WEBER COUNTY PLANNING DIVISION

Administrative Review Meeting Agenda

Staff Report to the Weber County Planning Division

Application Request:	Consideration, and action on a request for final approval of the Little Mountain Industrial Park Subdivision, consisting of six manufacturing lots.
Agenda Date:	Wednesday, April 22, 2026
Applicant:	Scott Carlson (Authorized Representative)
File Number:	LVL022526

Exhibit A

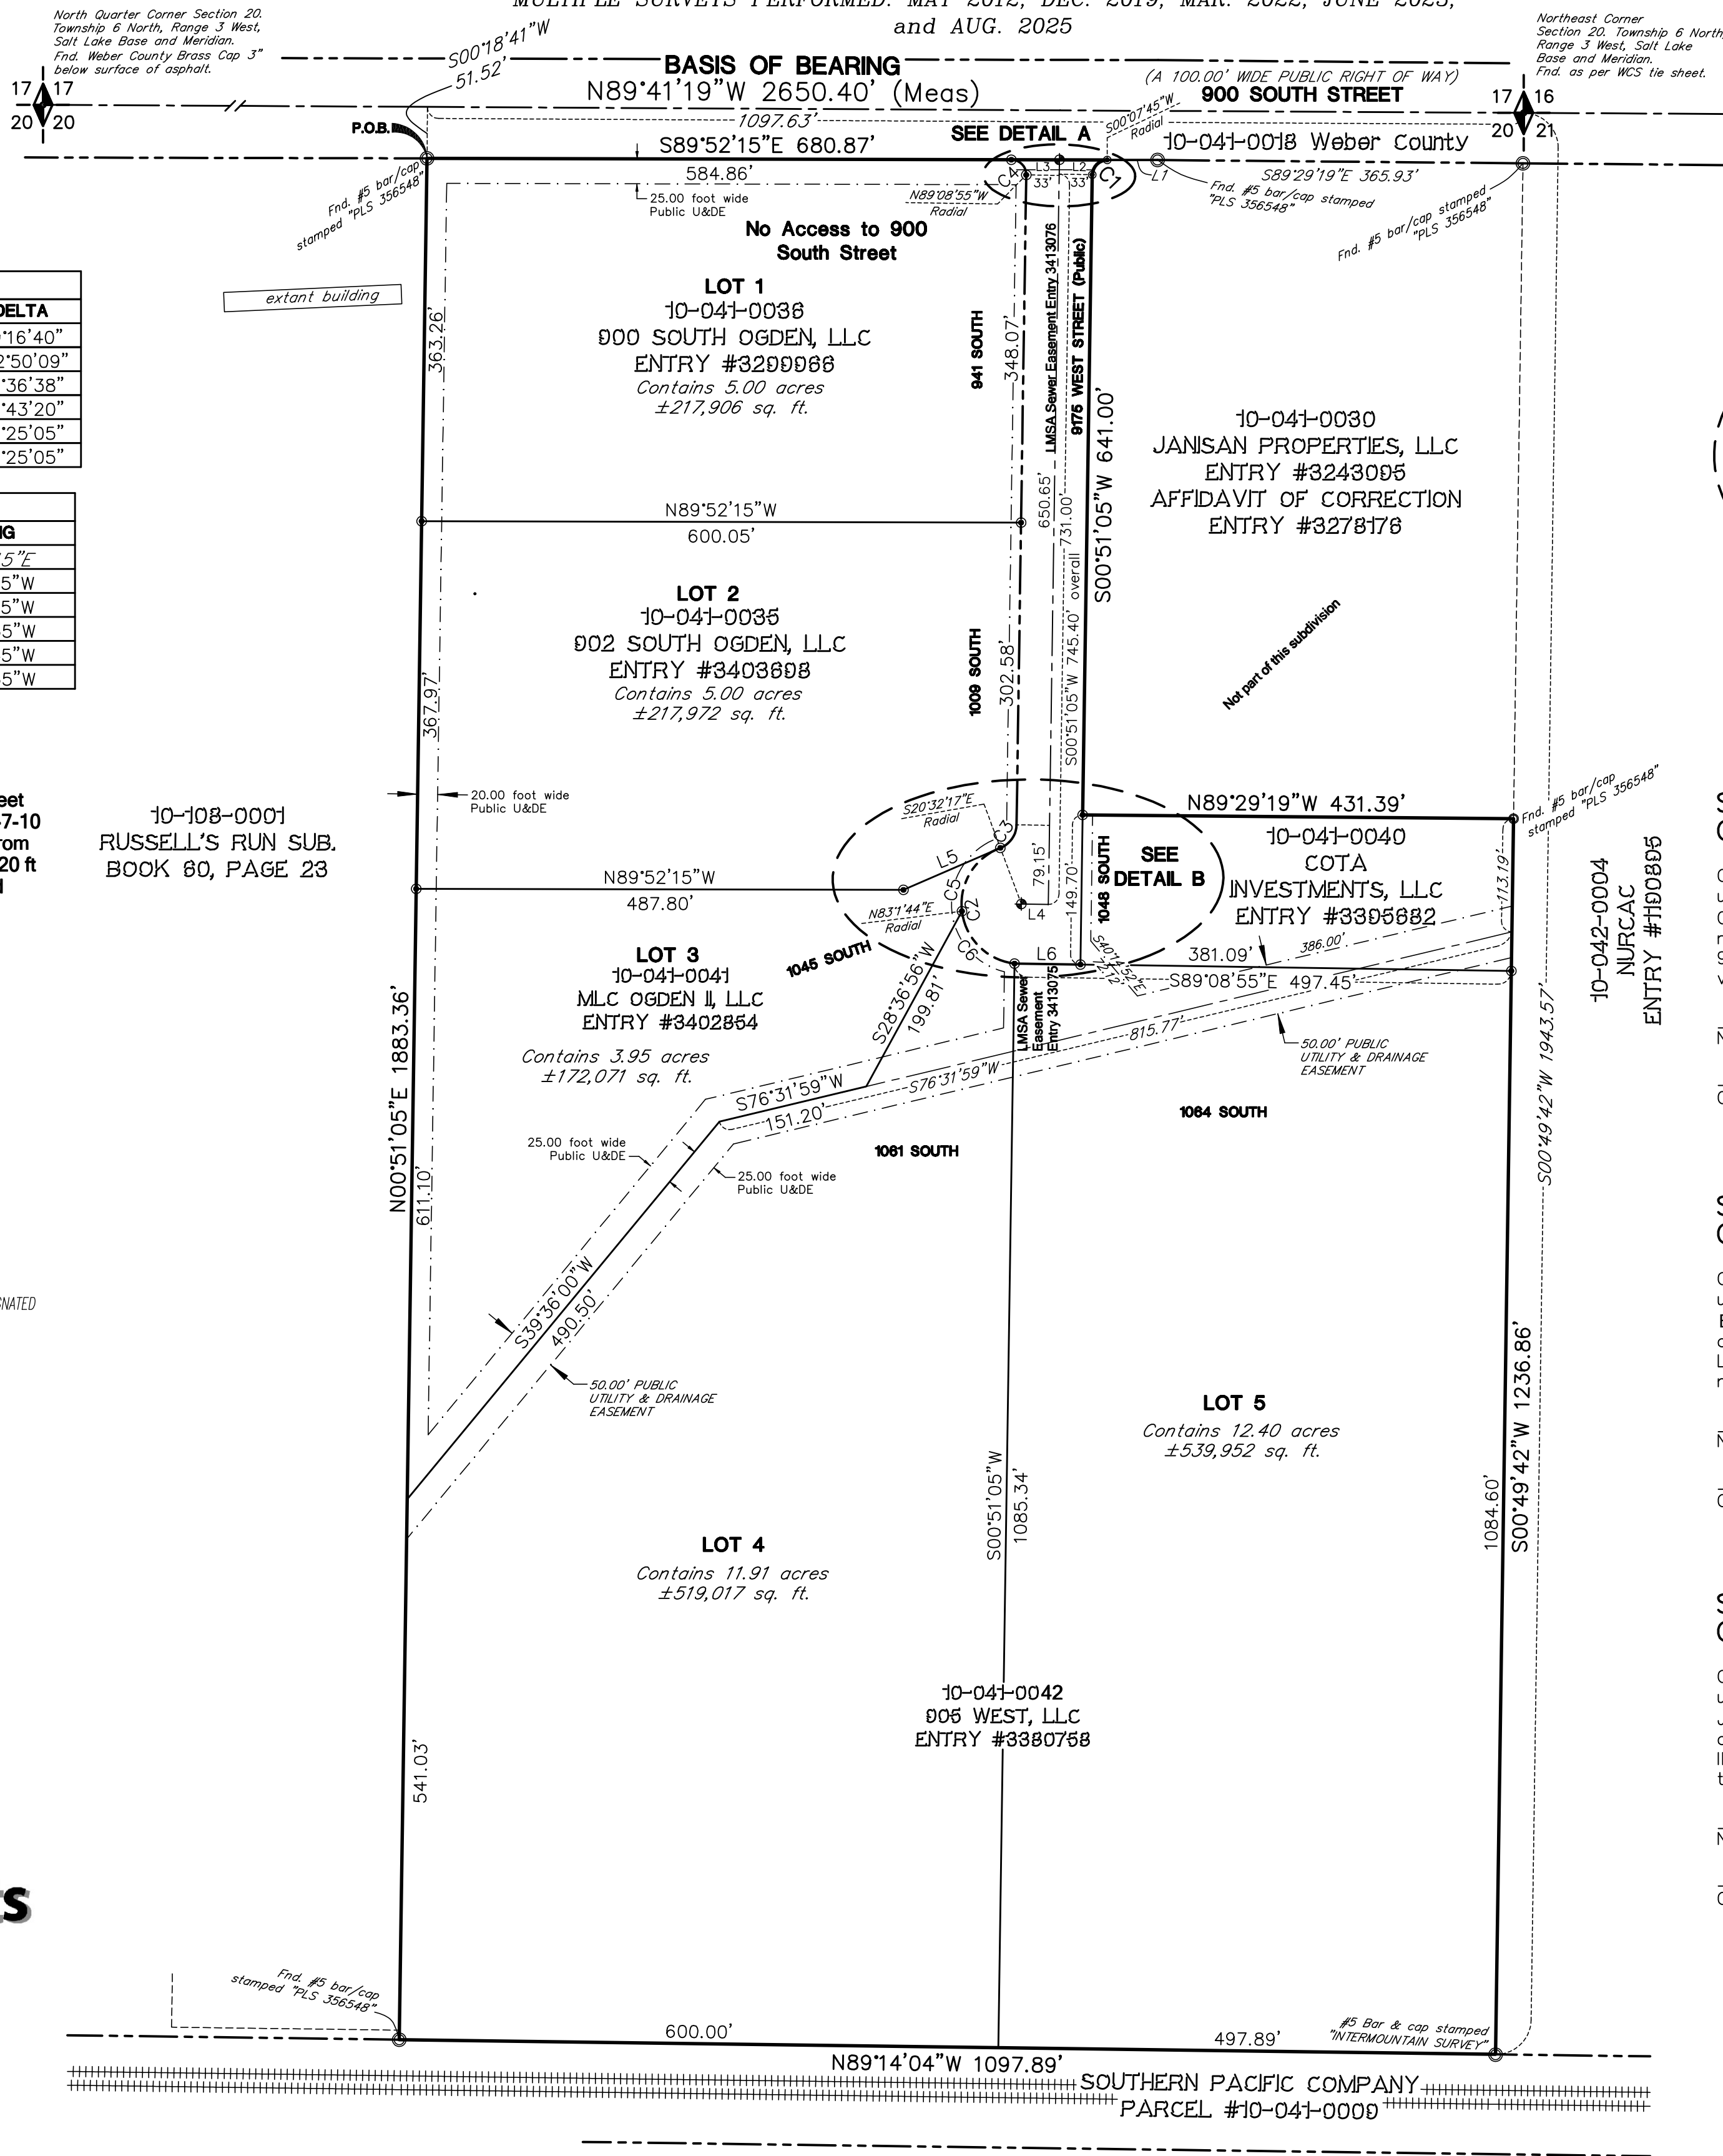
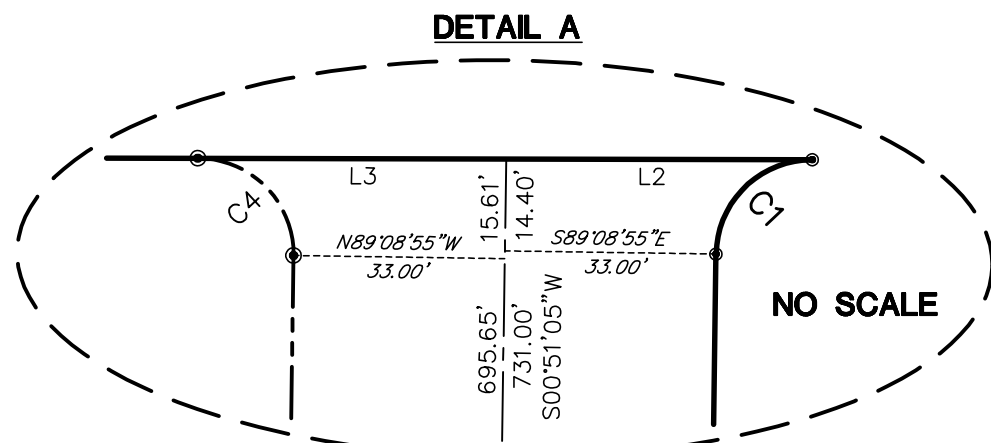
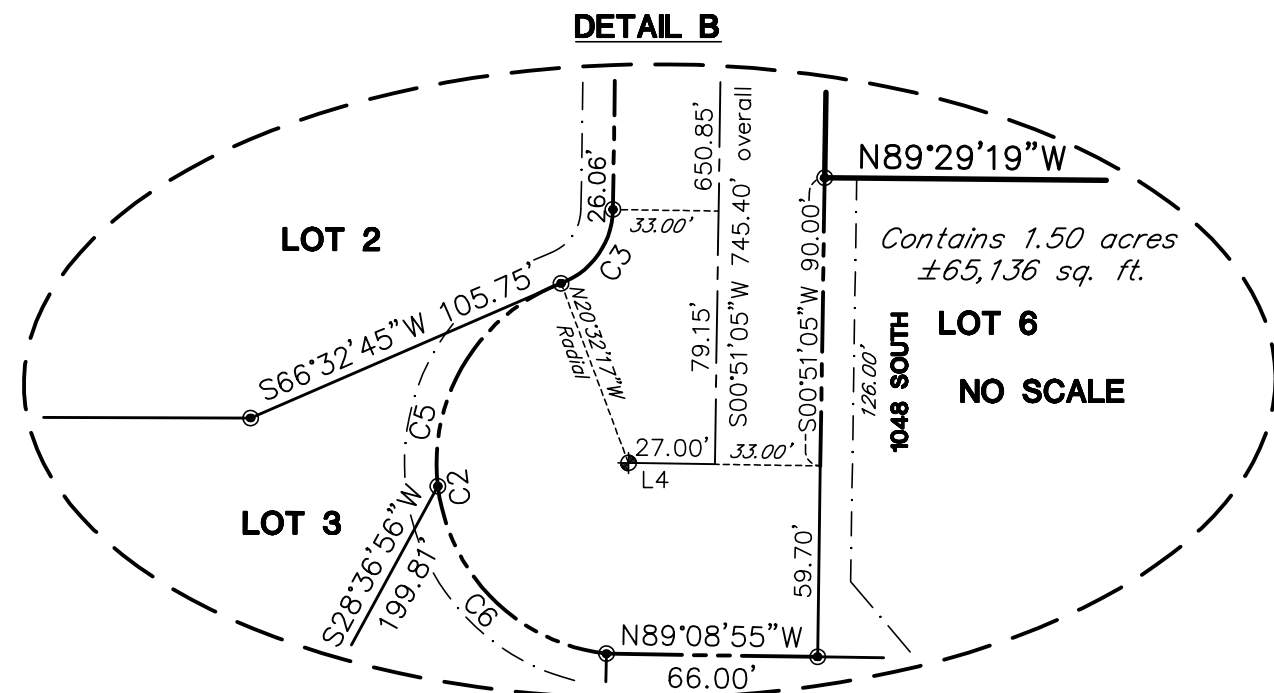
1. The subdivision plan shall include an easement for a Future Public Right-of-Way in an east-west direction with minimum building setbacks shown on the subdivision plat and the civil design plan. *This comment is made by the planning staff so that the subdivision plan would comply with the planned street alignments of the general plan. This comment has not been addressed.*

3. Parcel number 10-041-0030 shall be included with the subdivision plan to conform with Section 106-2-4.010 (f) Remnant Parcels. *This requirement remains outstanding. The parcel cannot be considered an agricultural parcel and should thereby be included with the subdivision.*

8. Minimum setbacks for all structures shall be measured from the future ROW line, which applies to 900 South, 9175 West, and the east-west right-of-way. *A note regarding this is on the subdivision plat, however the note does not mention 9175 West Street or the planned east-west ROW.*

2. 900 South Street at this location is planned for a 132' ROW. 66' from the centerline will need to be dedicated to the 900 South public ROW. See code Section 106-2-2.010 and 106-2-2.050.

5. The subdivision plan should, at minimum, show the appropriate ROW dedication for 900 South Street.

Per comments on prior review, the Connectivity plan already shows the potential corridor for possible future pathway and east west connection road. A PUE has been already been provided in the east west direction on the plat to preserve a corridor in the event that a future road is ever needed.

Explanatory note will be added to the plat

County master planned Right of Way for 900 South Street is 66 ft south of the section line. County code Sec 108-7-10 requires that building setbacks for Lot 1 be measured from that future ROW line. Code Sec 104-21-5 (c) identifies 20 ft side yard setback for corner lot in M3 zone which would apply to the north line of Lot 1.

See response to comment 2 above. 25 ft PUE has been shown to preserve the corridor. The County may wish to suggest purchasing a Road Preservation Easement if it does not want to initially purchase the full 16 feet of right of way as fee simple.
